DRWG No DA-02-C
PROPOSED SITE PLAN

DA2023/0493

PROPOSED ALTERATIONS TO FRONT FENCE AND ENTRY AND UNIT 4 BALCONY AND ASSOCIATED WORKS AT 8 OCEAN ROAD MANLY 2095 SP 14402			FOR THE OWNERS SP 14402		KUBANYI ARCHITECTS NSW REG 4087 DEP 0000592 LEVEL 1, 122 VICTORIA ROAD DRUMMOYNE 2047 PH 0412 500 240 JUDITHKUBANYI@IINET.NET.AU				DRWG NoDA-A03- D PLAN AT GFL LEVEL
					Scale 1:100@A3	Date April 14 2023	Drawn jk		
								issue DA

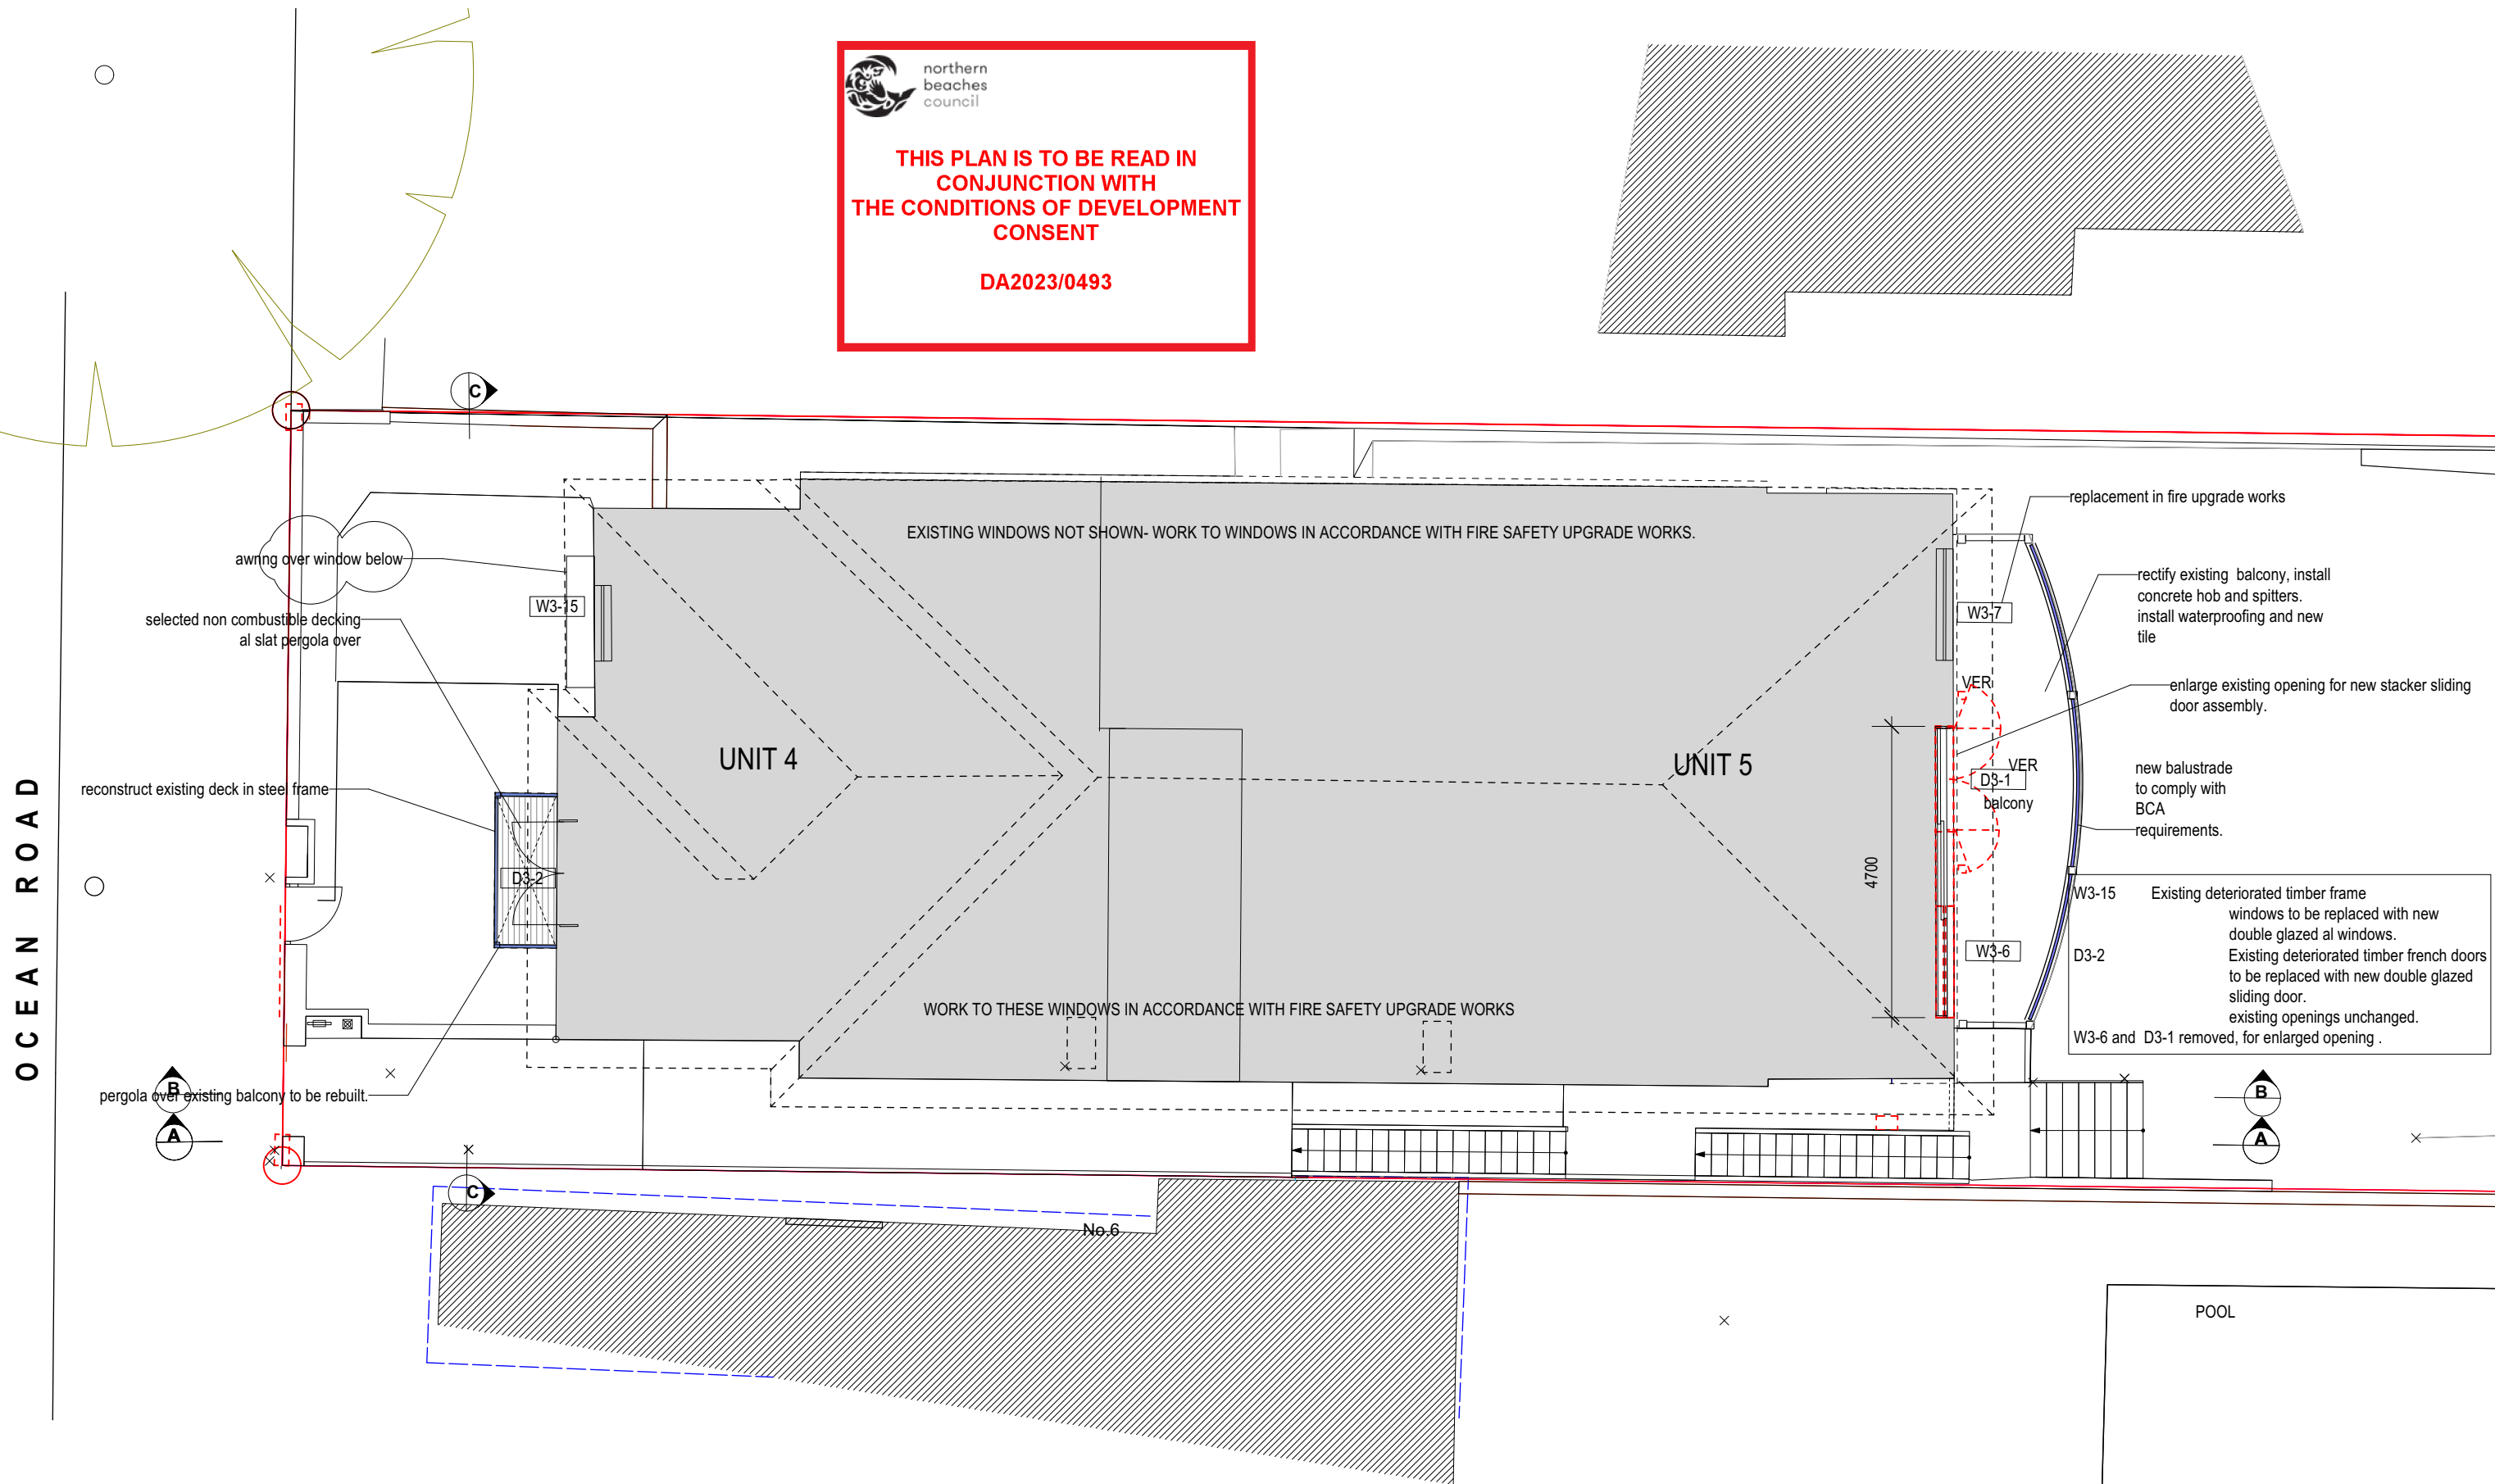
W2-6 ,W2-14	Existing deteriorated timber frame windows to be replaced with new double glazed al windows.
D2-2, D2-3	Existing deteriorated timber french doors to be replaced with new double glazed French doors. existing openings unchanged

E	31.10.2023	note added re retaining wall over on NW corner to be rebuilt
D	30.10.2023	awning required to comply with BASIX added
C	12.9.2023	slab and supporting structure required for sprinkler booster valve assembly deleted from this application as it is required Fire Safety Upgrade works . Replacement of partially collapsed retaining wall on NW corner of site added.
B	25.7.2023	reference to currently approved DA 2020/0875 deleted. new landing and stairs shown this DA

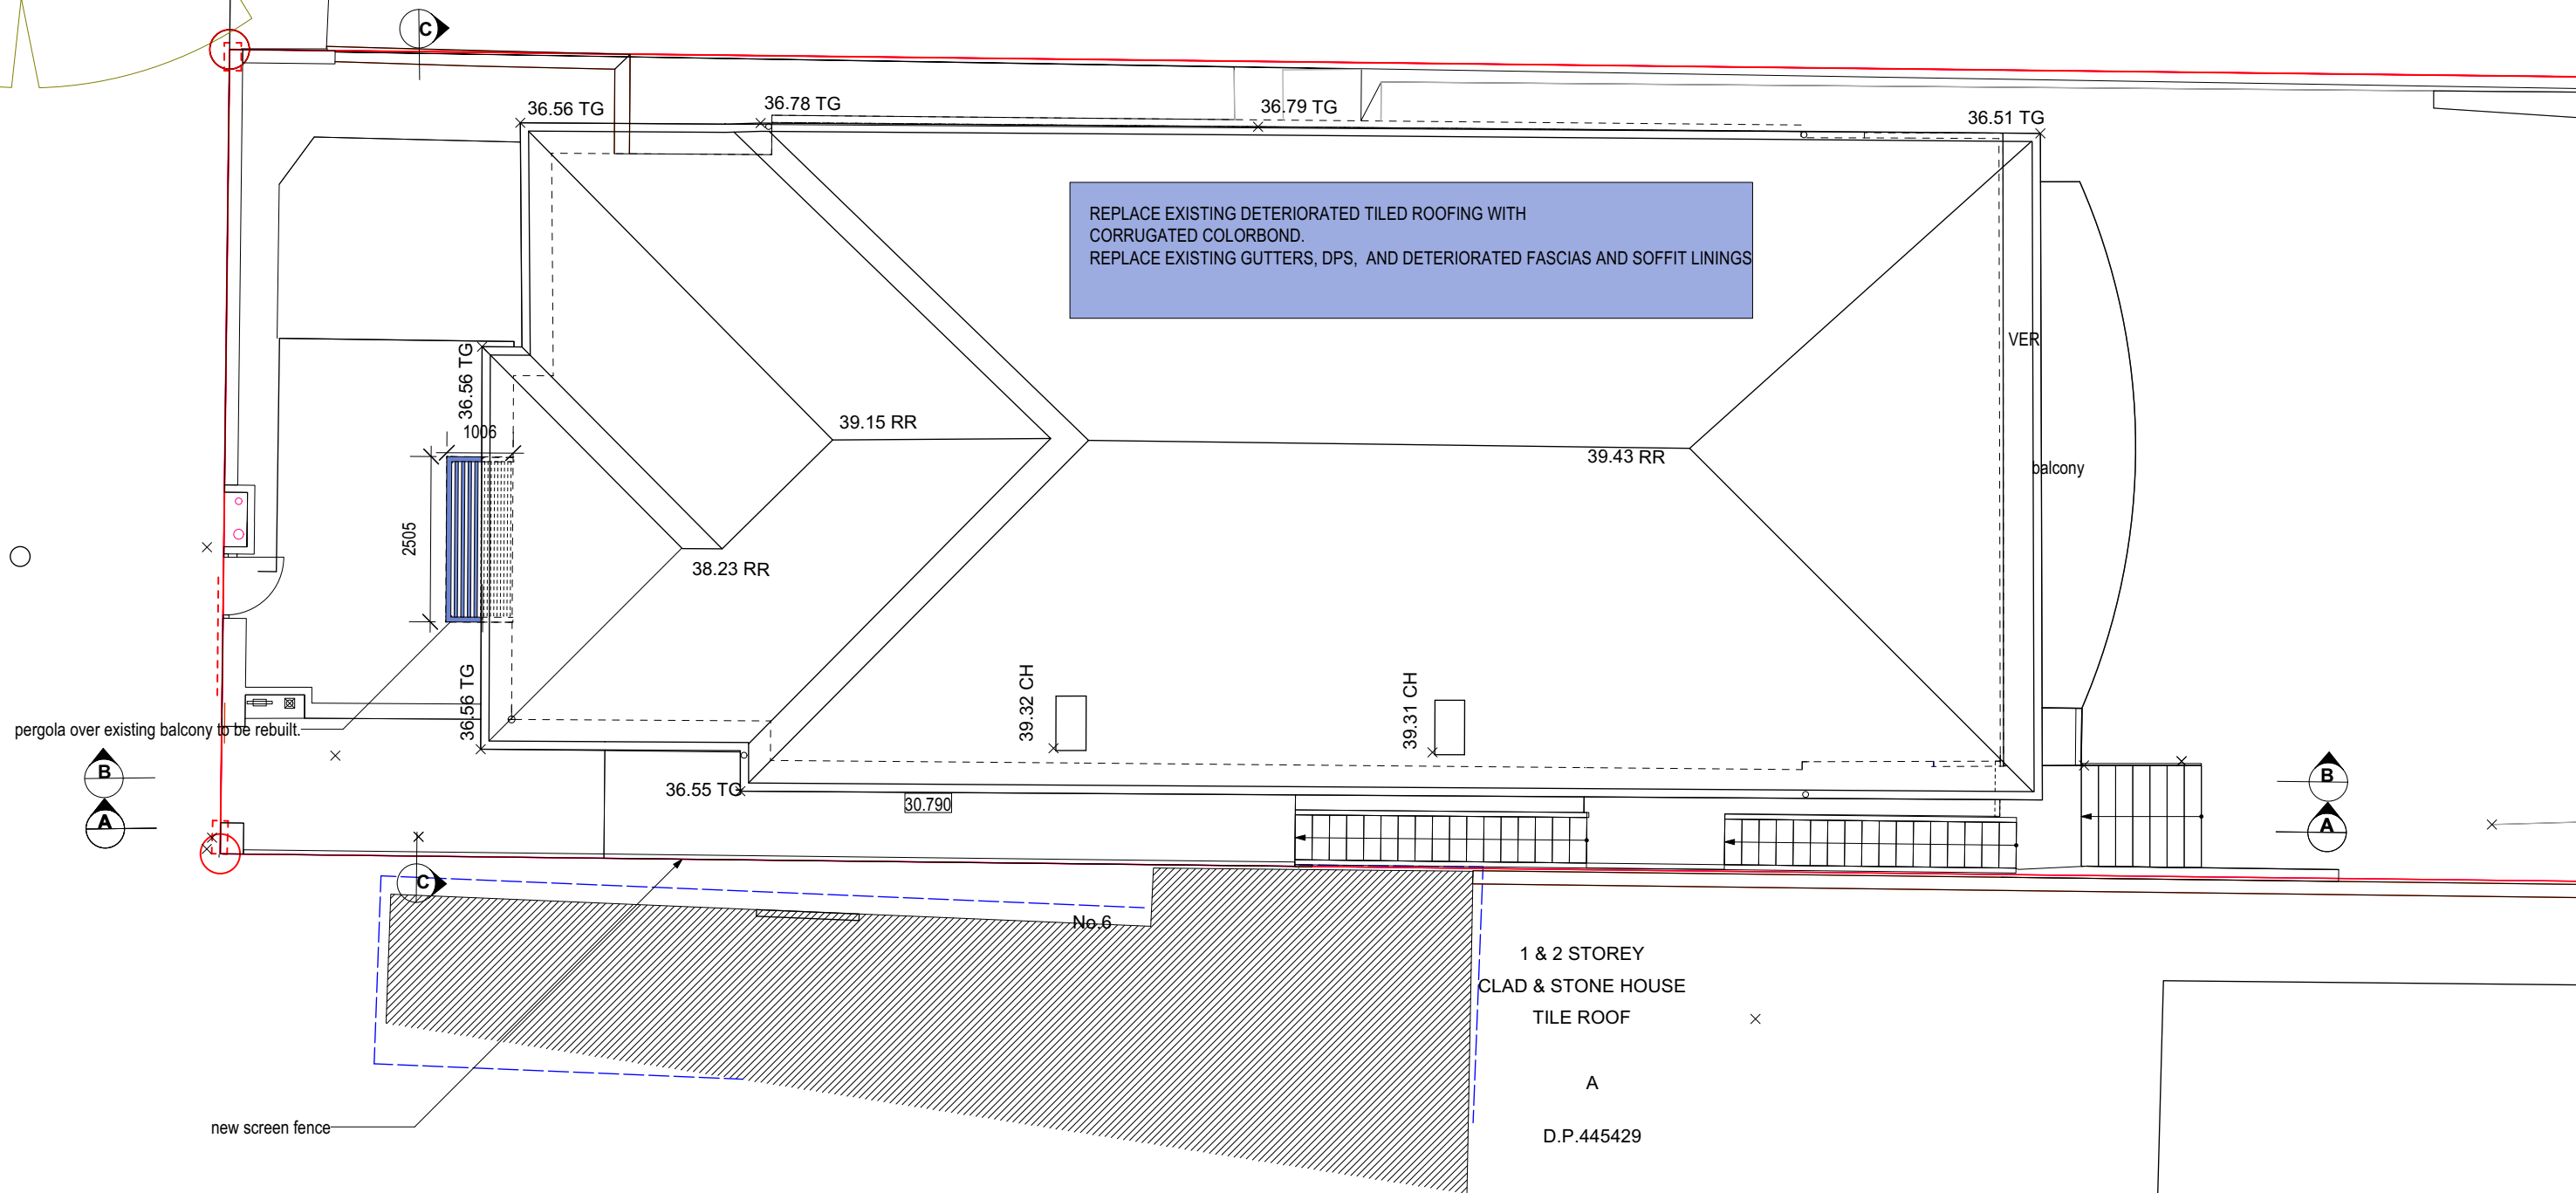
B	30.10.2023	awning required to comply with BASIX added
---	------------	--

DRWG No DA-A08- E

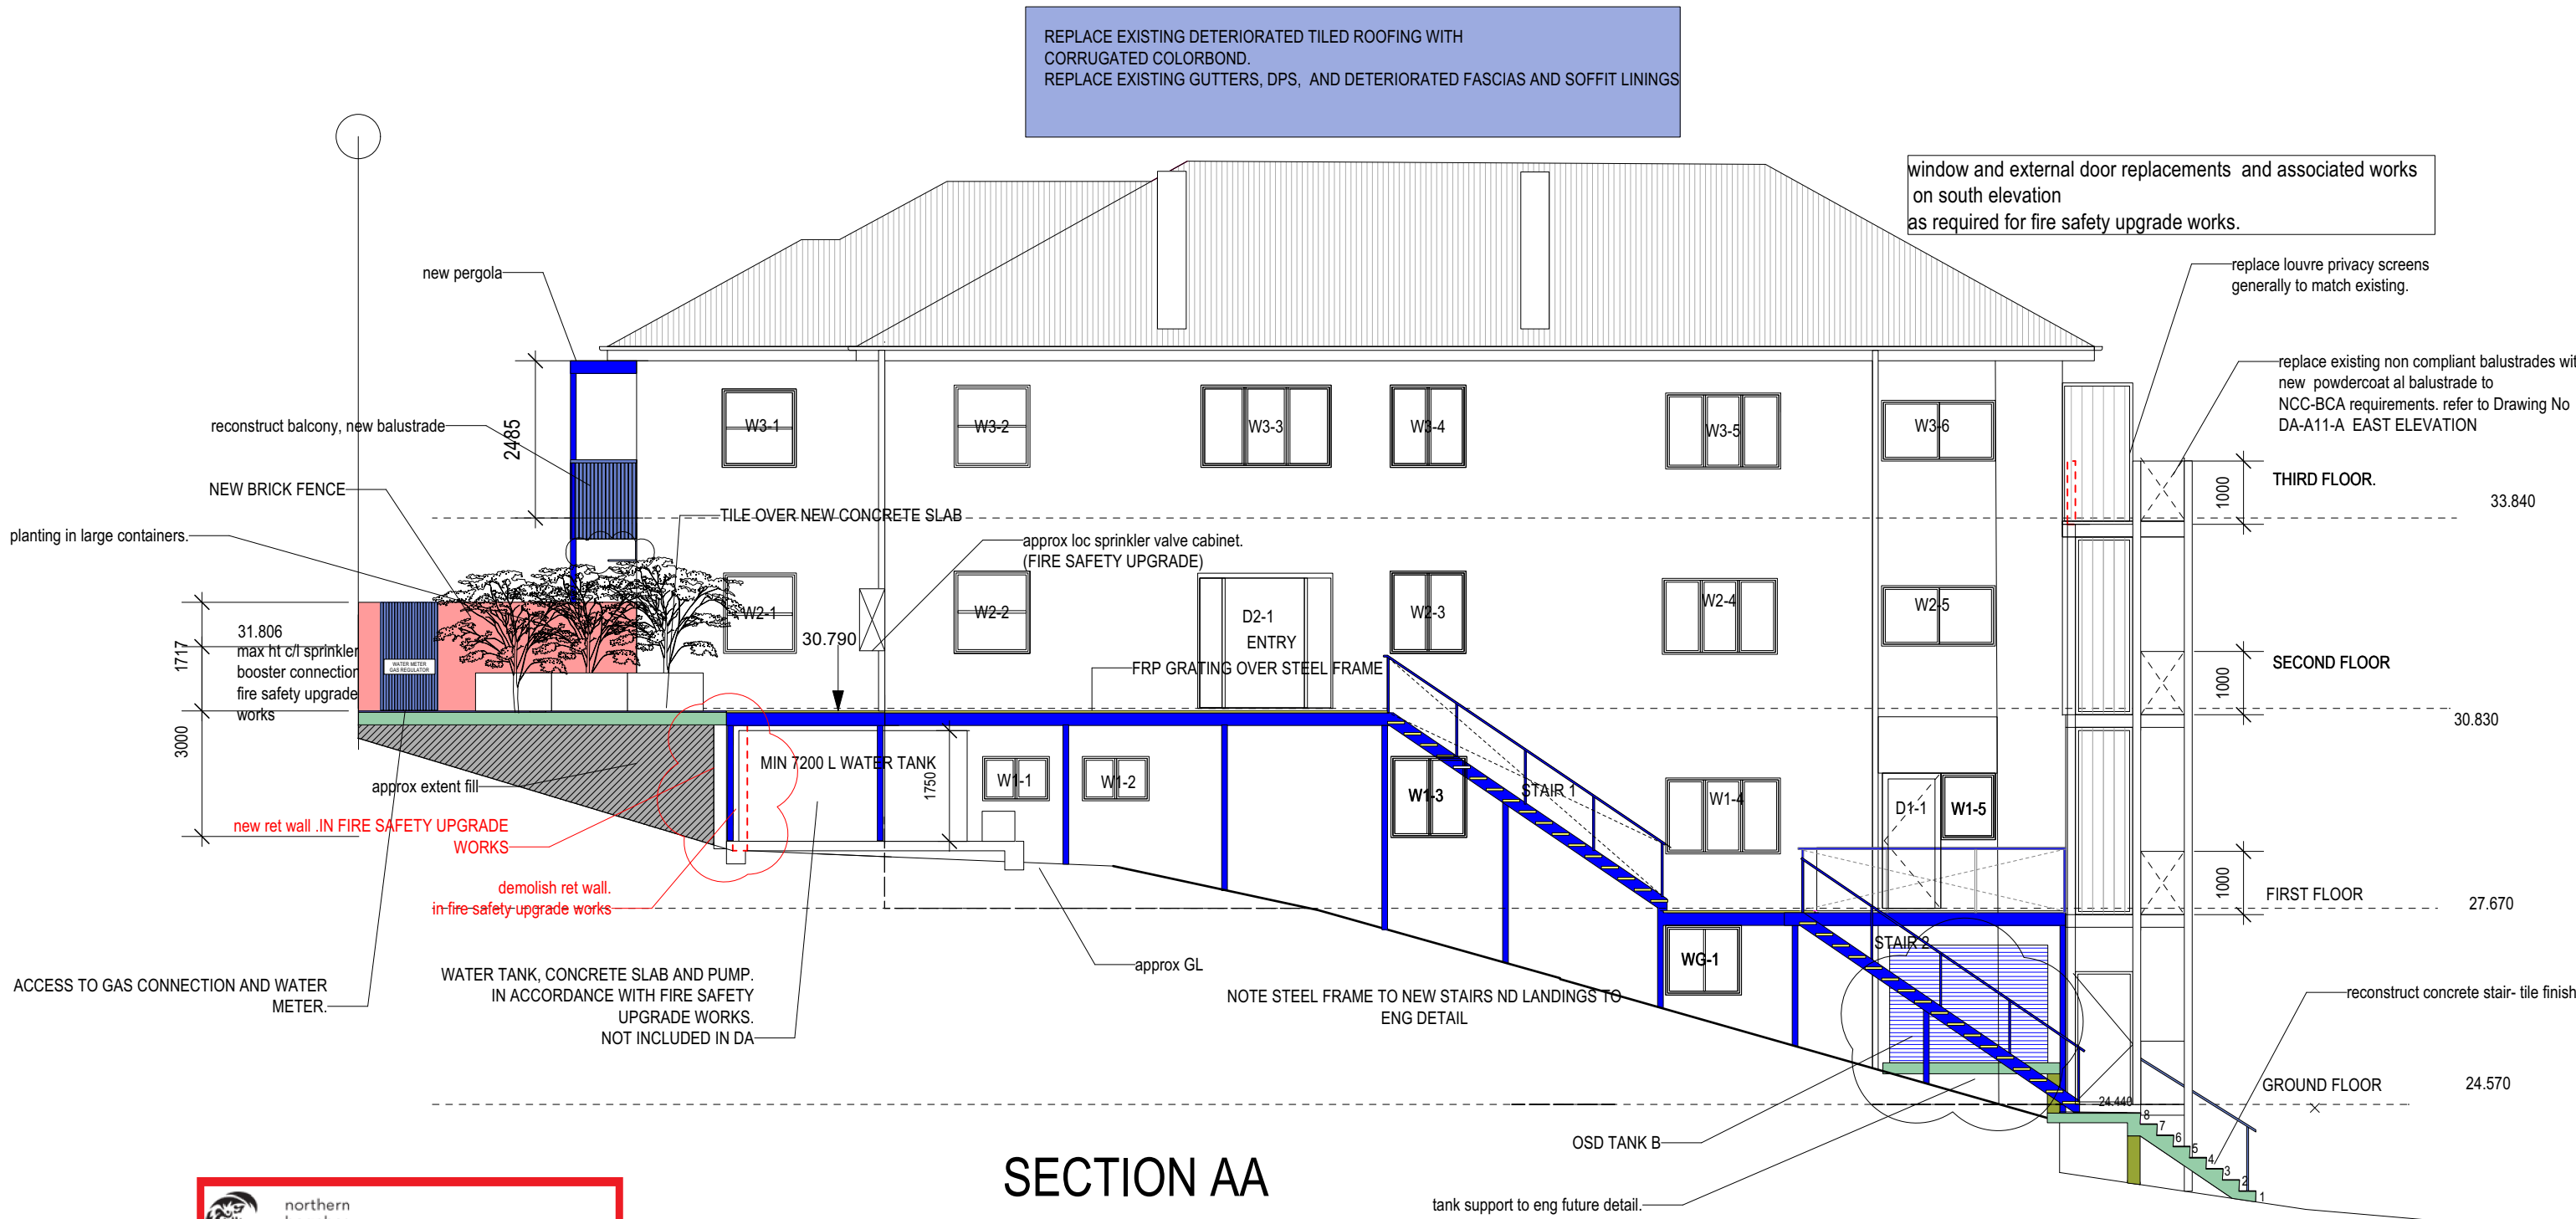
E	30.10.2023	awning required to comply with BASIX added
D	12.9.2023	new retaining wall , demolition of existing added to fire safety upgrade works- deleted from DA
C	7.8.2023	OSD tank location shown
B	25.7.2023	reference to currently approved DA 2020/0875 deleted.new landing and stairs shown.this DA . front fence ht reduced.
